SUBJECT: HOPE CREEK GENERATING STATION (TAC NO. M93054)

AMENDMENT TO FACILITY OPERATING LICENSE

Amendment No. 88
License No. NPF-57

SAFETY EVALUATION BY THE OFFICE OF NUCLEAR REACTOR REGULATION

FIGURE 2.4.6.1.1

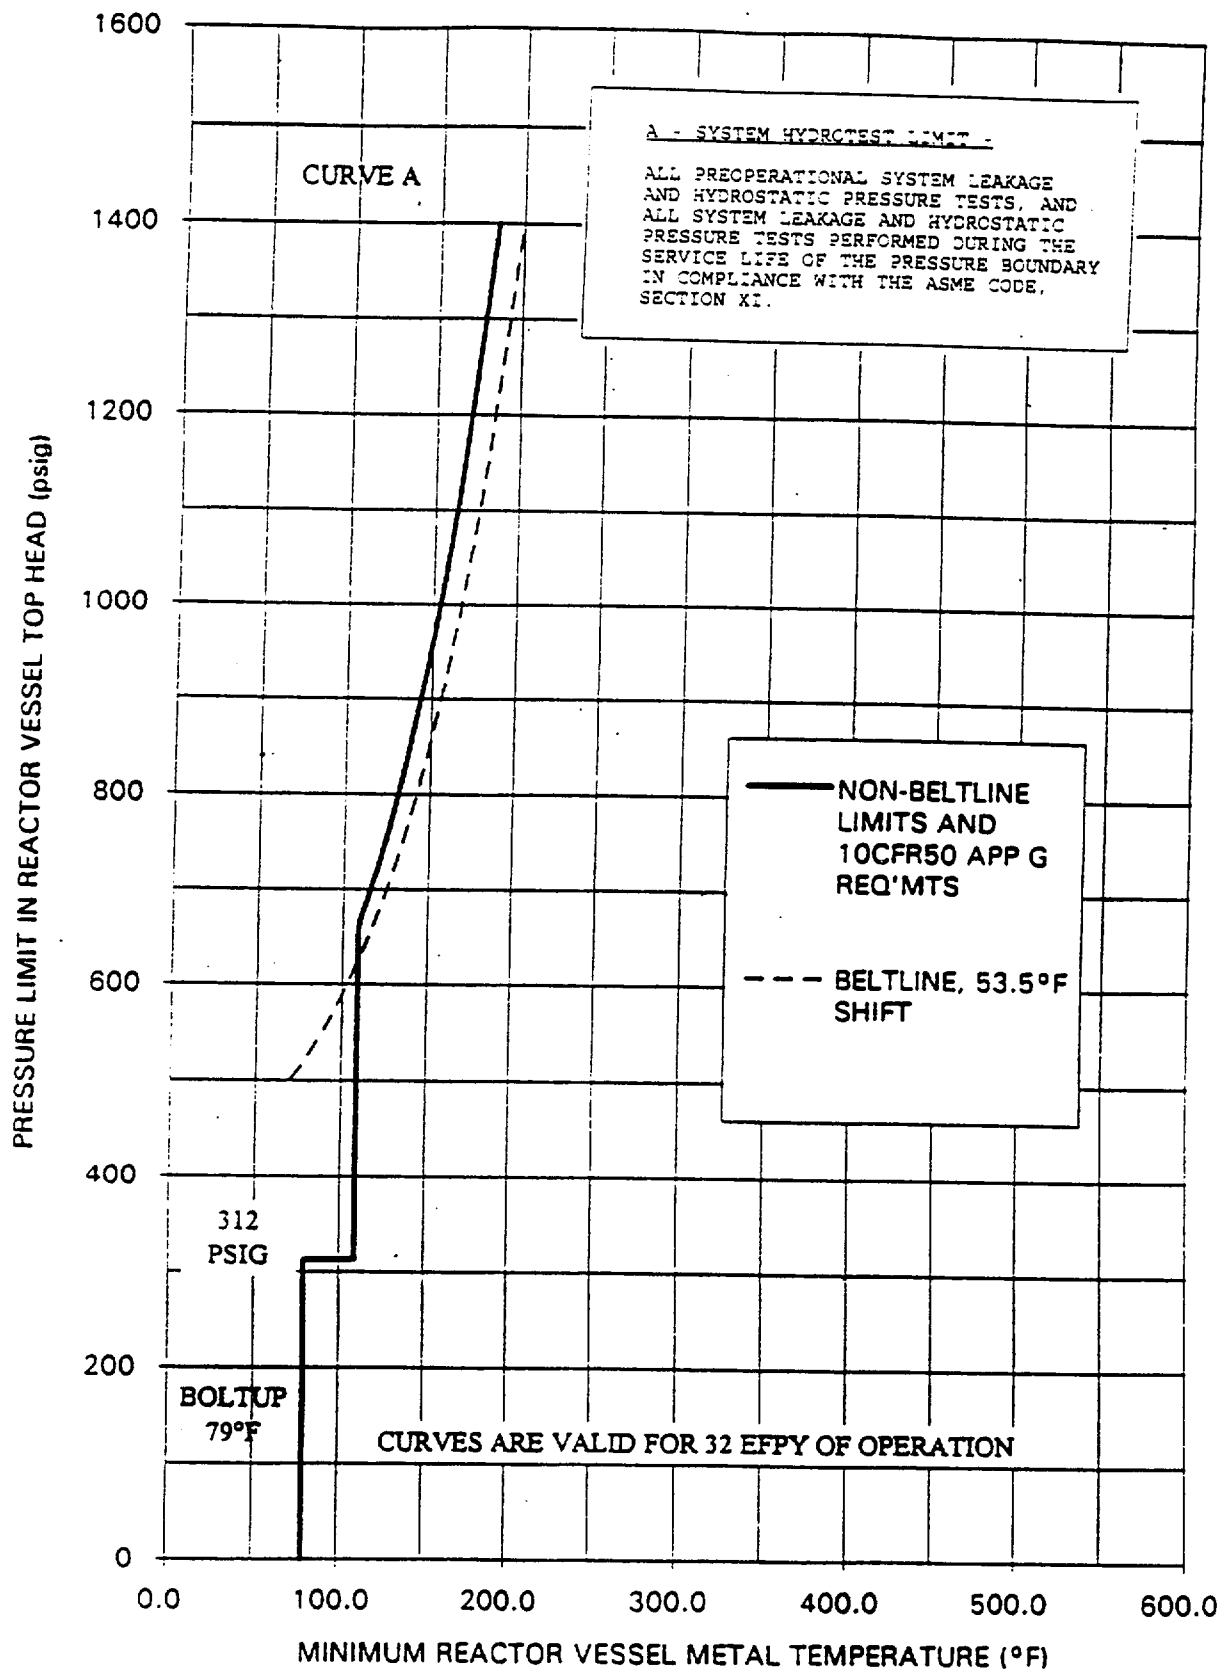
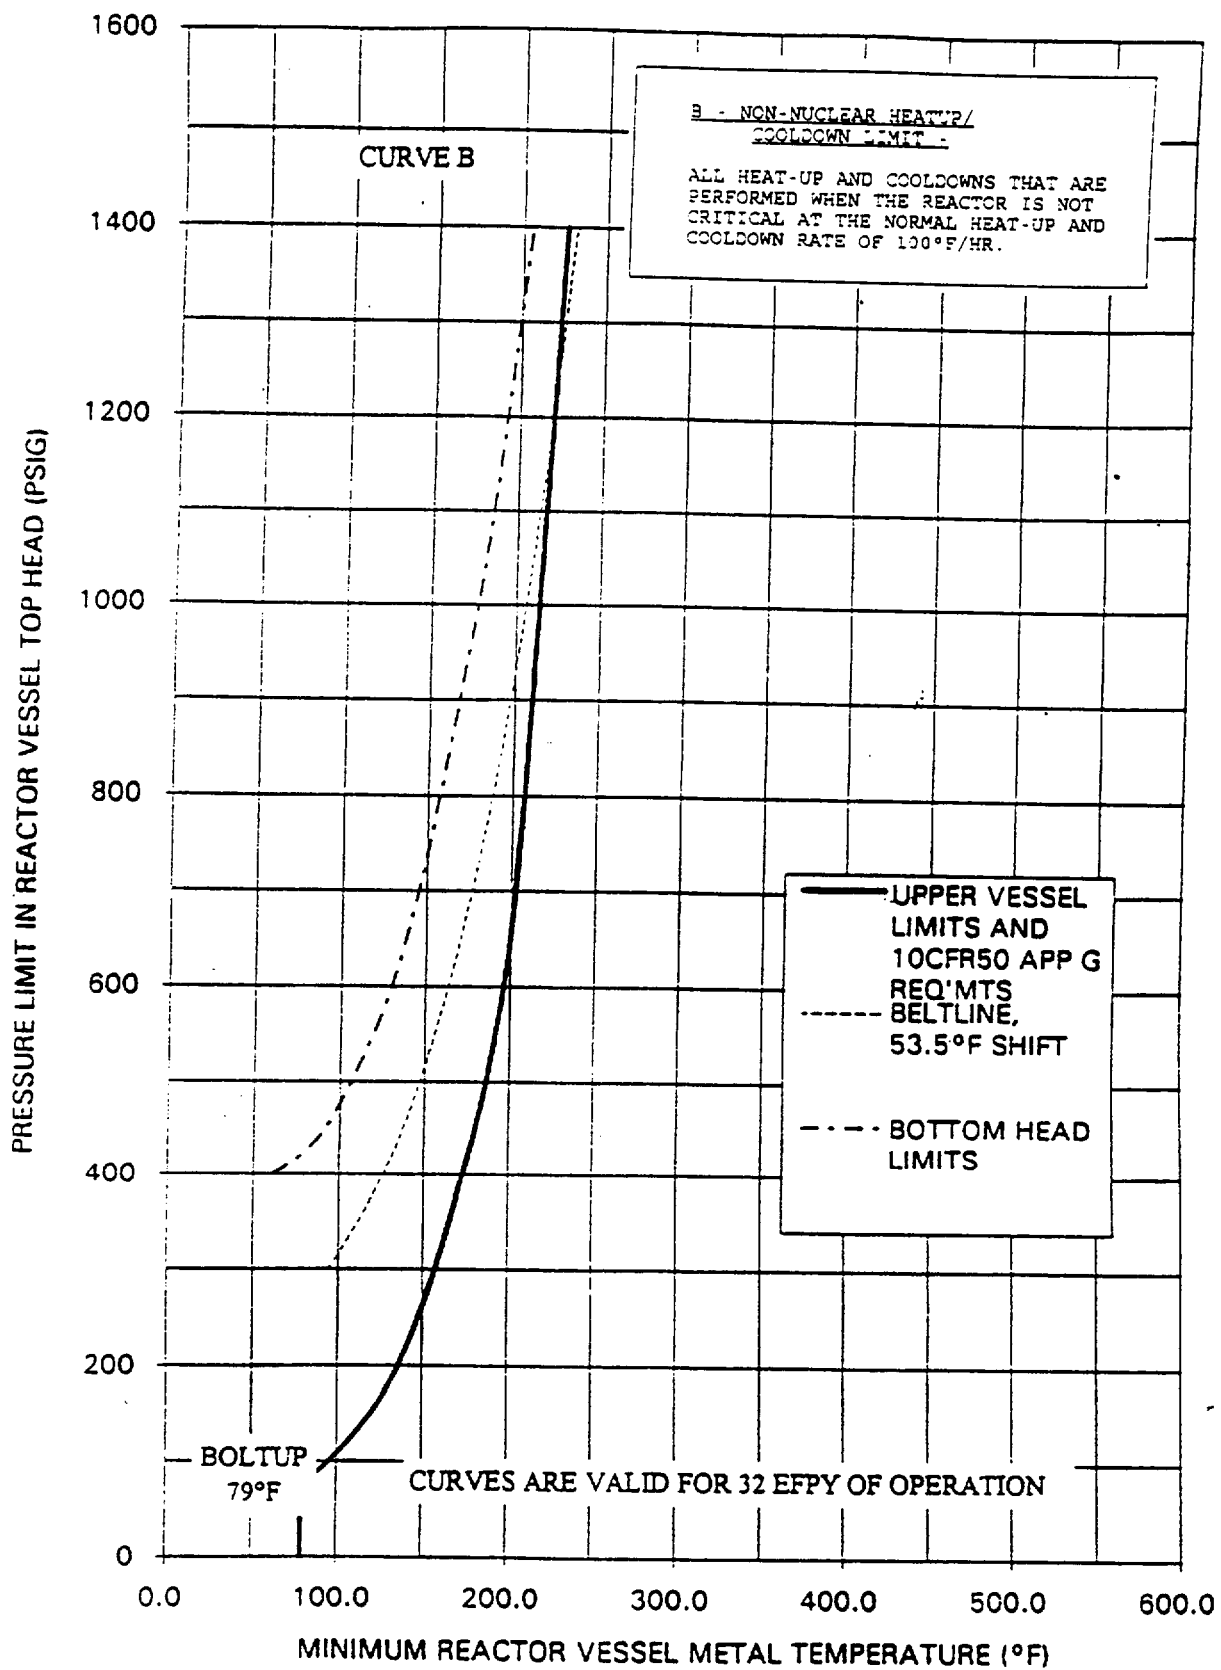
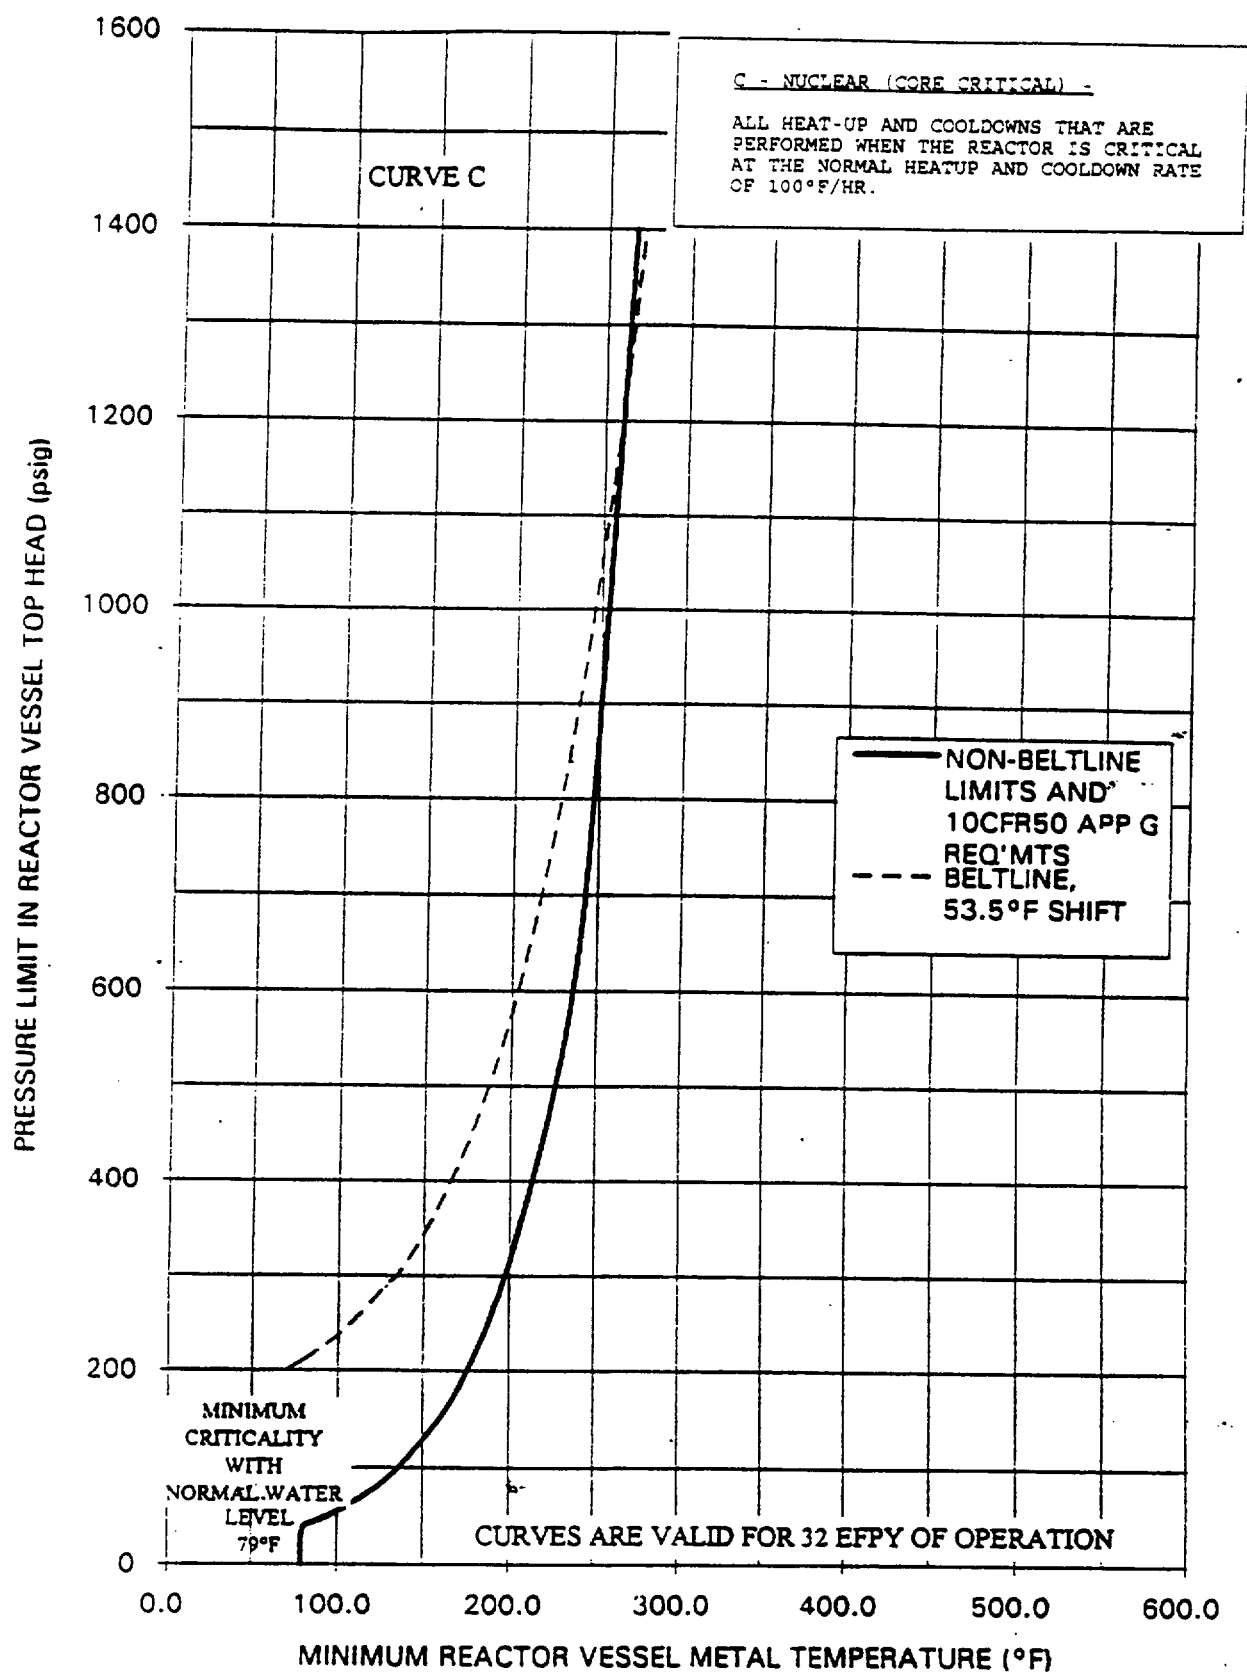
The Technical Specification (TS) revision incorporates updated pressure vs. temperature operating limit curves contained in TS Figure 3.4.6.1-1. The revision also changes TS Surveillance Requirement 4.4.6.1.3 based upon implementation of Regulatory Guide 1.99, Rev. 2, in accordance with Generic Letter 88-11, for reactor vessel material surveillance specimens. The changes are a result of data obtained from the first set of specimen capsules removed during refueling outage 5.

3.4.6.1 The reactor coolant system temperature and pressure shall be limited in accordance with the limit lines shown on Figure 3.4.6.1-1 (hydrostatic or leak testing), and Figure 3.4.6.1-2 (heatup by non-nuclear means, cooldown following a nuclear shutdown and low power PHYSICS TESTS), and Figure 3.4.6.1-3 (operations with a critical core other than low power PHYSICS TESTS), with:

Substituting the ART of the limiting material into equations in SRP 5.3.2, the staff verified that the proposed P/T limits for (1) hydrostatic or leak testing, (2) heatup by non-nuclear means, cooldown following a nuclear shutdown and low power physics tests, and (3) operations with a critical core other than low power physics tests satisfy the requirements in Paragraphs IV.A.2 and IV.A.3 of Appendix G of 10 CFR Part 50.

The staff has performed an independent analysis to verify the licensee's proposed P/T limits. The staff concludes that the proposed P/T limits for (1) hydrostatic or leak testing, (2) heatup by non-nuclear means, cooldown following a nuclear shutdown and low power physics tests, and (3) operations with a critical core other than low power physics tests are valid for 32 EFPY, because: 1) the limits conform to the requirements of Appendix G of 10 CFR Part 50 and GL 88-11, and 2) the material properties and chemistry used in calculating the P/T limits are consistent with or conservative compared to data submitted under GL 92-01; hence, the proposed P/T limits may be incorporated in the Hope Creek Generating Station TS 3/4.4.6.1. The licensee has also proposed deletion of the specific material surveillance methodology of TS 4.4.6.1.3a and b. Deletion of TS surveillance requirement 4.4.6.1.3a and b is acceptable because the licensee will utilize the calculation methodology in RG 1.99, Revision 2 to calculate embrittlement. The deletion does not affect the surveillance program. Hence, the licensee's surveillance program must still comply with 10 CFR Part 50, Appendix H. In addition, the proposed changes in the Bases section of the TS are consistent with the P/T limits changes and, therefore, are acceptable. ✓
